TRI-PARTY AGREEMENT

Change Notice Number TPA-CN- 0793	TPA CHANGE NOTICE FORM	Date: 8/22/2017
Document Number, Title, and Revision: DOE/RL-2014-27, Sampling and Analysis Plan for Remediation Wells in the 200-UP-1 Operable Unit, Rev. 2 1244003		Date Document Last Issued: March 2017

Description of Change:
Changes to the SAP are required to add 1 additional monitoring Well 699-30-73 that is planned for installation in fiscal year 2017/2018.

Figure 1-7. Planned Locations for the Southeast Chromium Plume Characterization Wells

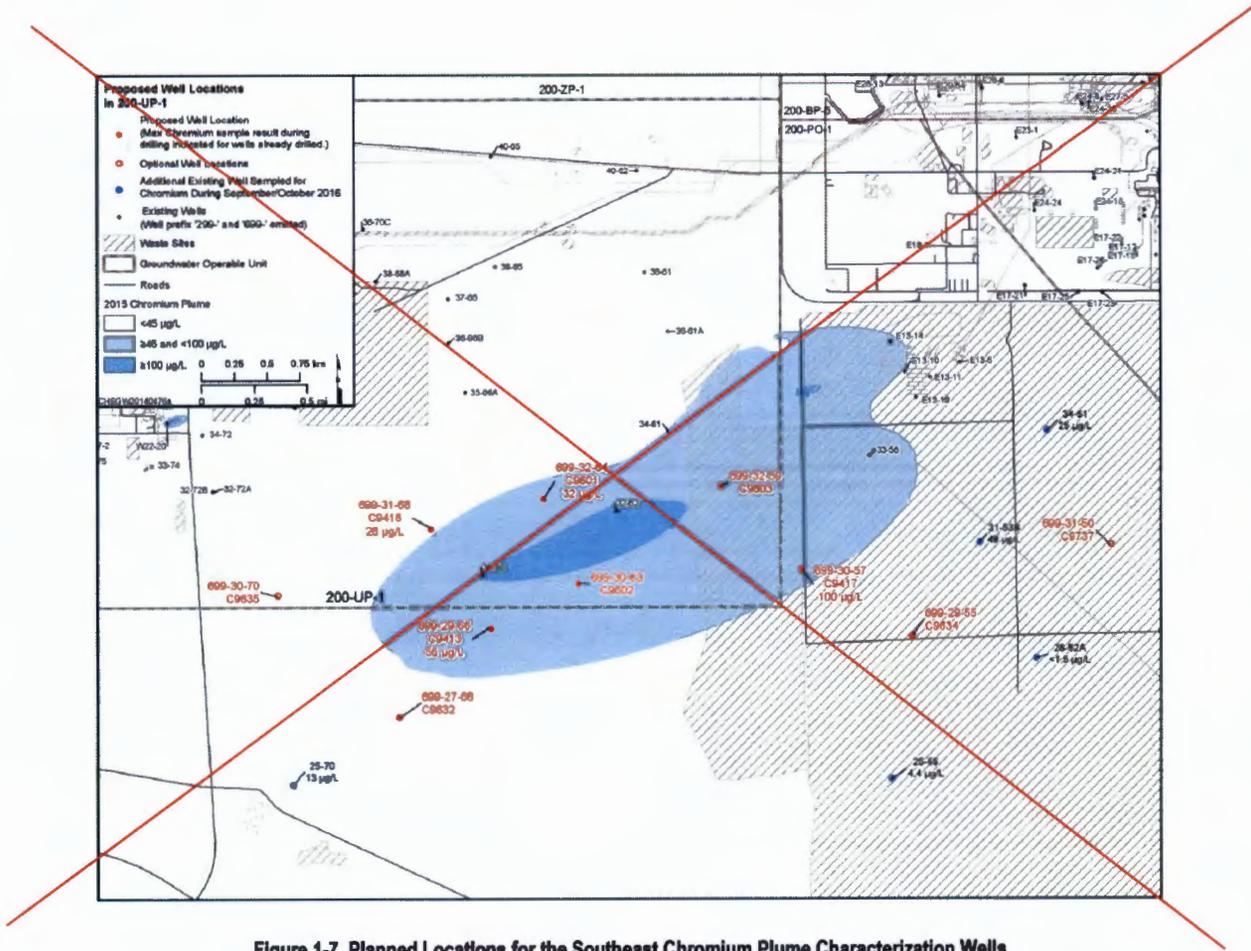
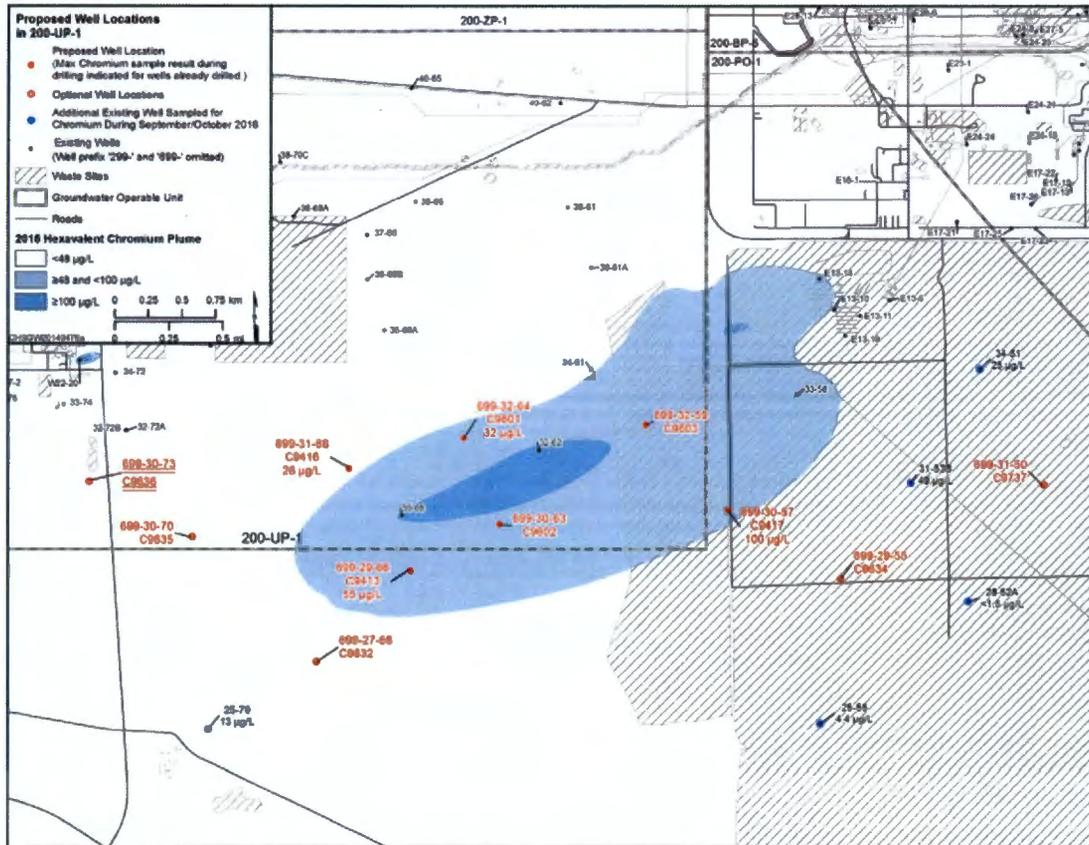
- Table 1-4, page 1-21, Well name, well type, parameter descriptions, and parameter values added to the table for Well 699-30-73.
- Figure 1-7, page 1-25, Well 699-30-73 added to the figure.
- Table 3-1, page 3-32, Well name, sample matrix, depth below water table, allowable variation, analytes, and comments added to the table for Well 699-30-73.
- Chapter 4, page 4-1, 4th Paragraph, text added to identify well 699-30-73 and the well numbers were changed accordingly.
